Access Compliance Report

Public Rights-of-Way

(Curb Ramps)

Intersection ID: 8276	Main Street: BROOKSHIRE_BV	Cross Street: N LINWOOD_AV	Location: SE
ADA ID: D17E3E8825B5	Ramp Type: Para	Initial Pass/Fail: Fail	Overall Compliance: No
Codes/Mitigation Info/Possible Solution		Field Measurements/Component Compliance	
Severity Score: 13.75

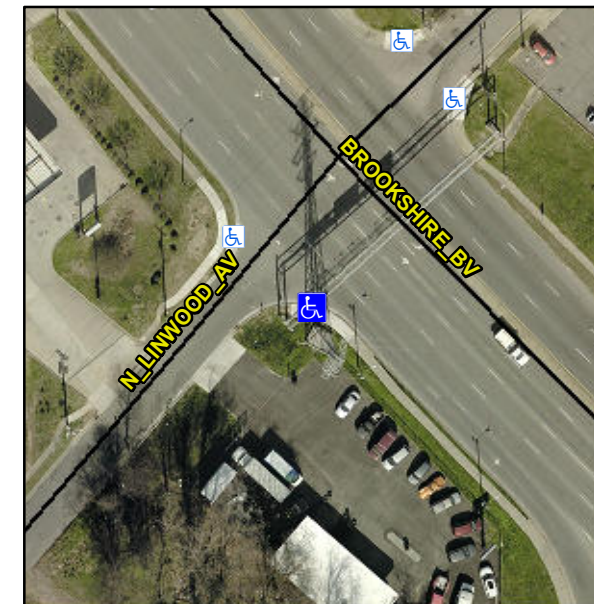
NO RT SW, RT RP < 5%

R304.3.2, R304.5.3

Compliance	Description	Data	Compliance	Description	Data
N/A	Ramp Length LT (in)	42.0	N/A	Ramp Length RT (in)	46.0
Yes	Ramp Width LT (in)	53.0	Yes	Ramp Width RT (in)	53.0
No	Ramp Slope LT (%)	11.9	Yes	Ramp Slope RT (%)	3.1
Yes	Ramp XSlope LT (%)	1.3	No	Ramp XSlope RT (%)	2.9
N/A	Landing Length (in)	N/A	N/A	DWS Provided?	N/A
N/A	Landing Width (in)	N/A	N/A	DWS Contrast?	N/A
N/A	Landing Slope (%)	N/A	N/A	DWS Length (in)	N/A
N/A	Landing X Slope (%)	N/A	N/A	DWS Full Width?	N/A
N/A	Landing Curb? (Y/N)	N/A	N/A	DWS Offset (in)	N/A
N/A	Shared Landing?	N/A			
N/A	Gutter Ponding?	N/A	N/A	Gutter Slope (%)	N/A
N/A	Gutter Lip Ht (in)	N/A	N/A	Gutter X Slope (%)	N/A
N/A	Painted X Walk1?	No	N/A	Painted X Walk2?	N/A
	X Walk 1 Direction	To NW		X Walk 2 Direction	N/A
N/A	X Walk 1 Width (in)	N/A	N/A	X Walk 2 Width (in)	N/A
	X Walk 1 Slope (%)	0.2		X Walk 2 Slope (%)	N/A
	X Walk 1 X Slope (%)	6.8		X Walk 2 X Slope (%)	N/A
N/A	Ramp inside XWalk1?	N/A	N/A	Ramp inside XWalk2?	N/A

Possible Solutions:

Remove & Replace Entire Ramp.
